No. : SI-V48056
Date: Oct.15,1993

SERVICE INFORMATION

No. : SI-V48117-G

MODEL : CLD-A100 g S/M NO :: ARP2757 PAGE : 11,13,14

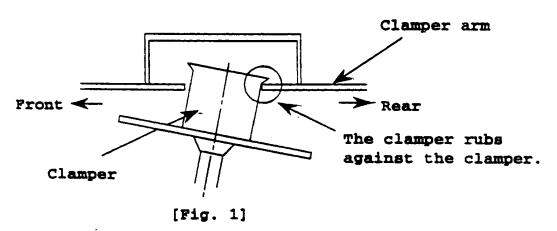
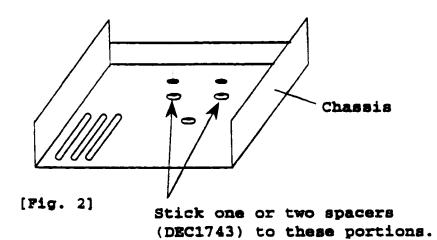
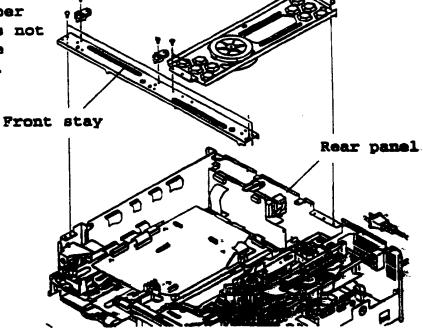
MODEL NO.	SER. NO.	MODEL NO.	* SE	R. NO.	MODEL NO.	*	SER.	NO.
CLD-A100/KU	A NH3606101-							
CLD-A100/KU	B NI3614001-							
# DE	TAIL OF CHANGE	S)			REASON FOR CHANGE			
1 Change of	the shape of	Chassis		_	rent mechanical sing audible wh			
2 Change of Rear panel and Front stay, and deletion of spacers				sc i	played

<CAUSE>

When an LD disc is clamped, the motor center axis is slanted due to:

- The height of the mech mounting portions on the Chassis is lower by 0.5mm.
- The mounting position of the mechanism is deviated toward the rear side.

Therefore, the clamper rubs against the clamper arm at the rear side.

<SERVICE REMEDY>

When you encounter the above problem:

- Stick 1 or 2 spacers (DEC1743) to the mech mounted portions of the chassis. (See Fig. 2) (One spacer has already been stuck there from the 1st production.)
- 2. If mechanical noise remains after the spacers are stuck, replace the rear panel and the front stay with the new parts (DNA1135 & DNE1207).
 - * As to the rear panel and the front stay, only the new parts are available.

<COUNTERACTION IN FACTORY>

- 1) Improved the shape of the chassis.
- 2) Changed Rear panel and Front stay, and deleted spacers from the chassis.

Rear panel: N.S.P. ---> DNA1135
Front stay: DNE1207 ---> DNE1207*
Spacers (x4): DEC1743 ---> Deleted

* Although the part number for the front stay has not been changed, only the new part is available.

MODEL [S/M NO.]	PAGE	INCORRECT	CORRECT
CLD-A100 (ARP2757)	80

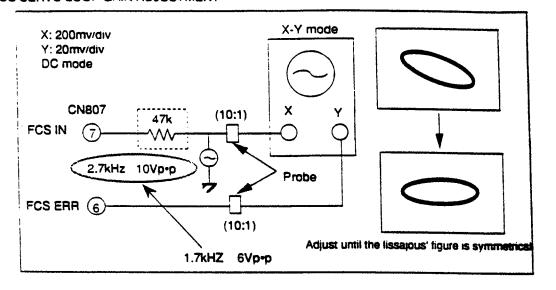
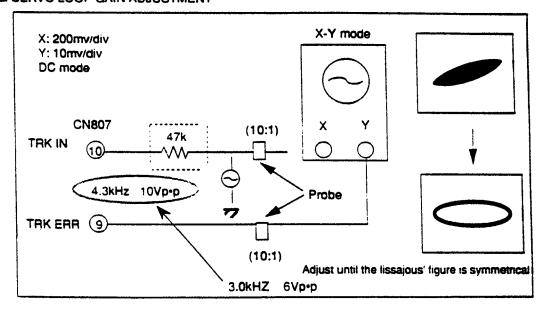
FCS SERVO LOOP GAIN ADJUSTMENT

TRKG SERVO LOOP GAIN ADJUSTMENT

FIG.3:VIDEO ASS'Y-PARTS MOUNTED SIDE

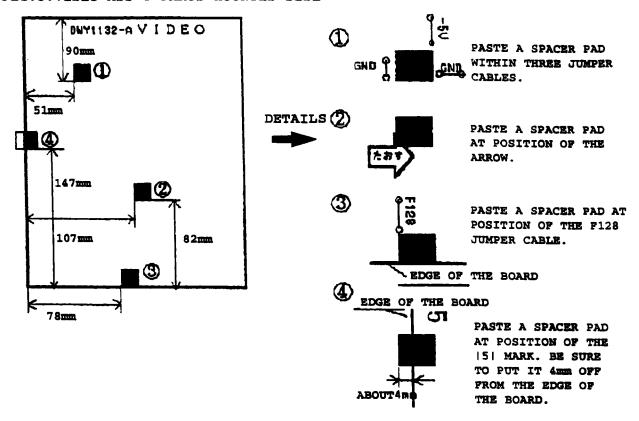
MODEL NO.		SER. NO.	MODEL NO.	•	SER. NO.	MODEL	NO.	*	SER.	NO.
CLD-A100/KU	A	3620701							<u> </u>	
								\Box		
								\Box		
										<u>-</u>
# DI	ETAI	L OF CHANGE	(S)		F	EASON FOR	CHAN	GES		
				Ш						
1 DETECTOR	05	SPACER PADS	ON WIREO	X	TO PREVE	NT THE 12	INCH	DIS	ic.	
ASS'Y	OF	SPACER PADS	ON VIDEO			NG SCRATCE				
ASS I				Ш						
				<u> </u>						
									ERVICE	MANUA
<pre><pre><pre><pre><pre><pre><pre><pre></pre></pre></pre></pre></pre></pre></pre></pre>	THE	12 INCH DIS	SC GETS SCRATCE	ied w	ITH A CIR	CULAR MAR	κ.	,		_
								MOI	DEL :C	LD-A100
<cause> DU</cause>	ET	O CLOSE DIST	rance between 1	THE I	DISC AND V	IDEO ASS'	Y	ĺ		
IN	TH	E DISC CLAM	PED STATUS, PAI	RTS (CAPACITOR	S,ETC.)]	S/	M NO.	ARP2757
MC	UNT	ED ON VIDEO	ASS'Y CONTACT	WITH	THE DISC	WHEN A		Í		
SE	OCK	IS APPLIED	TO THE UNIT DO	JRING	PLAYBACK	, CAUSING	A	PA	GE : 4	ιο ,
CI	RCU	LAR SCRATCH	ON THE DISC.							
]										/
FIG.1	_		FIG.2			(CAPACITO	RS)	MO	DEL:

SPACER PAD KIT: GXX1089

PARTS INCLUDED IN THE KIT: ① -③ REB1187 (WITH ADHESIVE TAPE) X 3

DEB1044 (WITH ADHESIVE TAPE) X 1

*NOTE (1) PLEASE LOCATE A SPACER PAD WITHIN +-1.0mm IN TOLERANCE.

COUNTER ACTION AT FACTORY> IN ADDITION OF THE SAME ACTION AS SERVICE REMEDY, TWO CABLE BINDERS HAVE BEEN ELIMINATED AT THE FACTORY.

[FIG.1: AUDIO MIX CIRCUIT OF SSUB ASSY]

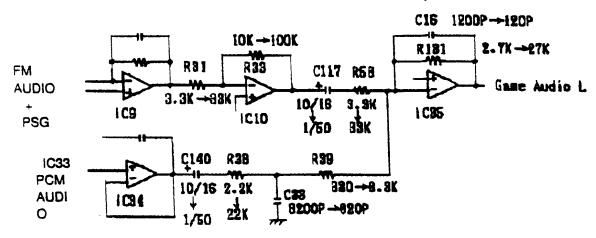
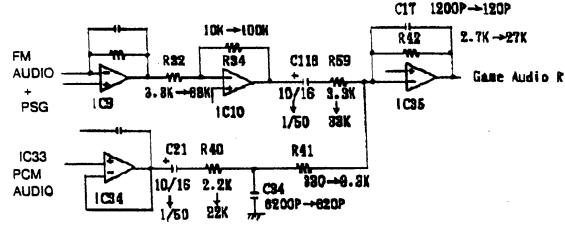
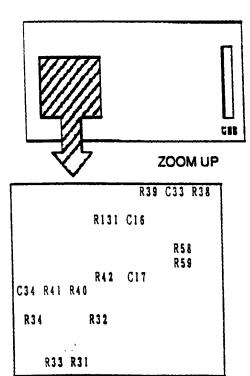
MODEL NO.	٠	SER. NO.	MODEL NO.	•	* SER. NO. MODEL NO. * SER.				NO.
_	PAC-S10/ZU	A	6919901-							
H										
L										
#			IL OF CHANGE	(4)			71.001 502 677	$\perp \perp$		
1			DIO MIX CIRC		x	REASON FOR CHANGES X TO PREVENT HIGH FREQUENCY AUDIO OF GAME SOFTWARE FROM BEING DISTORTED				
								S	ervice	MANUAL
<pre><problem> WHEN A CERTAIN SEGA GAME SOFT HIGH FREQUENCY AUDIO IS DIST</problem></pre>							o <i>,</i>	МО	DEL :P	AC-810
<cause> IN CASE THE RECORDING LEVEL OF HIGH IN AUDIO, AUDIO OUTPUT IS DISTORTED DUE TO HIGH CURE MIX CIRCUIT.</cause>					T FRO	M OP-AMP (S	SUB ASSY: IC10)		M NO.:	ARP2779

Ref.	CURRENT	PARTS	co	NEW PARTS			
* #	SYMBOL/DESCRIPTION	IPTION PART NUMBER DE		PART NUMBER	SYMBOL/DESCRIPTION		
A 1	R31	RS1/108332J	1	R\$1/10\$333J	R31		
A 1_	R32	RS1/108332J	1	R\$1/108333J	R32		
A 1	R58	R\$1/108332J	1	RS1/10S333J	R58		
A 1	R59	R\$1/108332J	1	R\$1/108333J	R59		
A 1	R33	R\$1/108103J	1	R\$1/108104J	R33		
A 1	R34	RS1/10S103J	1	RS1/10S104J	R34		
A 1	R38	R81/108222J	1	RS1/108223J	R38		
A 1	R40	RS1/10S222J	1	R\$1/10\$223J	R40		
A 1	R39	RS1/108331J	1	R\$1/108332J	R39		
A 1	R41	R81/108331J	1	R\$1/108332J	R41		
A 1	R42	R81/108272J	1	RS1/108273J	R42		
A 1	R131	RS1/108272J	1	R\$1/108273J	R131		
A 1	C33	CCSQCH822J50	1	CCSQCH821J50	C33		
A 1	C34	CCSQCH822J50	1	CCSQCH821J50	C34		
A 1	C16	CCSQCH122J50	1	CCSQCH121J50	C16		
A 1	C17	CCSQCH122J50	1	CCSQCH121J50	C17		
A 1	C117	CEV100M16	l	CEV010M50	C117		
A 1	C118	CEV100M16	1	CEV010M50	C118		
A 1	C21	CEV100M16	1	CEV010M50	C21		
A 1	C140	CEV100M16	1	CEV010M50	C140

PLEASE MODIFY THE AUDIO MIX CIRCUIT AS SHOWN BELOW.
